LINOTYPE IMPROVEMENT SHEET

NO. 301

ASSEMBLING ELEVATOR LEVER SHAFT SLEEVE

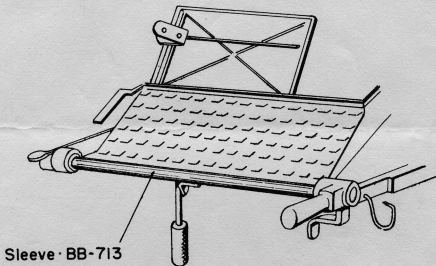
A Black Fibre Sleeve (BB-713) has been added to the Assembling Elevator Lever Shaft to prevent corrodng of steel Shaft, due to contact with operator's hands.

All new Model 5, 29, 30, 31, 32, 33, 34, 35 & 36 Machines.

Can be applied to all outstanding Machines.
